Mr and Mrs Taylor

East Yorkshire Solar Farm Nationally Significant Infrastructure
Project

Registration Comments

March 2024

Appendix 3

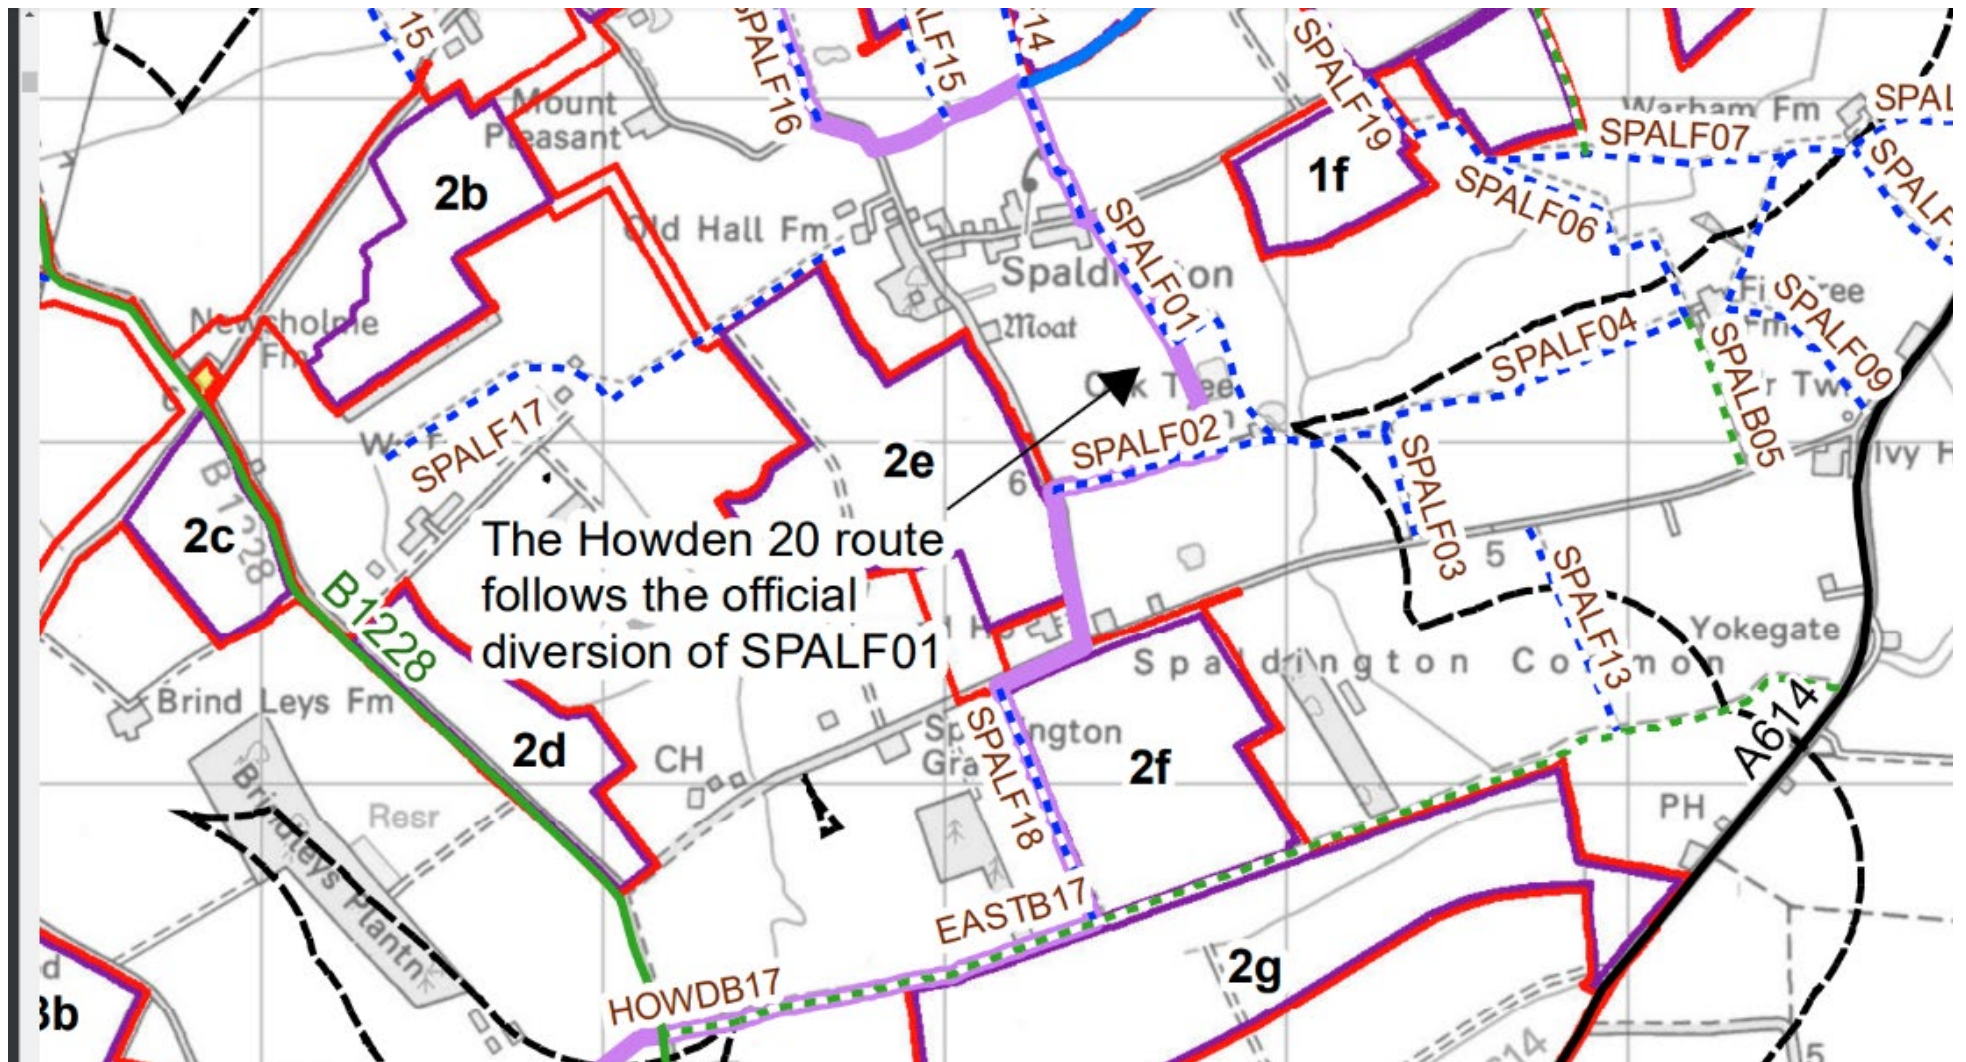
- 3.7. The applicant has not minimised harm to the landscape in this discrete area (Areas 2e and 2f). The Indicative Site Layout Plan (sheet 4) (see **Appendix 3** of this submission) shows a small flower rich grassland strip to the south of our clients’ property followed by the existing hedgerow and proposed perimeter fencing. This proposed mitigation is not considered ‘reasonable’ for the visual and landscape impacts in this area. The proposal’s almost exclusive reliance on planting to reduce the impact on visual amenity fails to maintain, respect or retain long views and the general openness of the local landscape that is central to its character.

- 3.8. Proposed woodland planting to the immediate south of Spaldington Road will permanently change the current openness of the landscape, including long distance views from Spaldington Road and Sandwood House that extend over a substantial field to the mature tree-lined horizon at the south of parcel 2f. In addition, there is an absence of mitigation planting adjacent to SPALF18 and EASTB17, with open and urbanising views of perimeter fencing and solar panels likely to be experienced. The creation of grassland and small areas of woodland edge planting do little to mitigate this.

- 3.10. With regards to parcel 2e, proposed species-rich grassland and a hedgerow with trees will do little to mitigate the immediacy of the array to receptors adjoining its southern boundary within Sandwood Business Park and the neighbouring equestrian land-use. The assessment of effects fails to consider the elevated line of sight experienced by horse-riders and greater levels of visibility experienced above features such as

- 7.2. The reinstatement of historic field boundaries and woodland (as illustrated on historic Ordnance Survey mapping) would represent a more logical strategy of inform the scale and extent of buffers to both the north and south of Sandwood House. The reinstatement of historic field boundaries in those locations would provide a framework of primary mitigation embedded in the scale and siting of the proposal. This could, in turn, allow areas of open field to be retained alongside Spaldington Road, Howden 20, SPALF18 and EASTB17, while delivering a logical framework of landscape restoration.
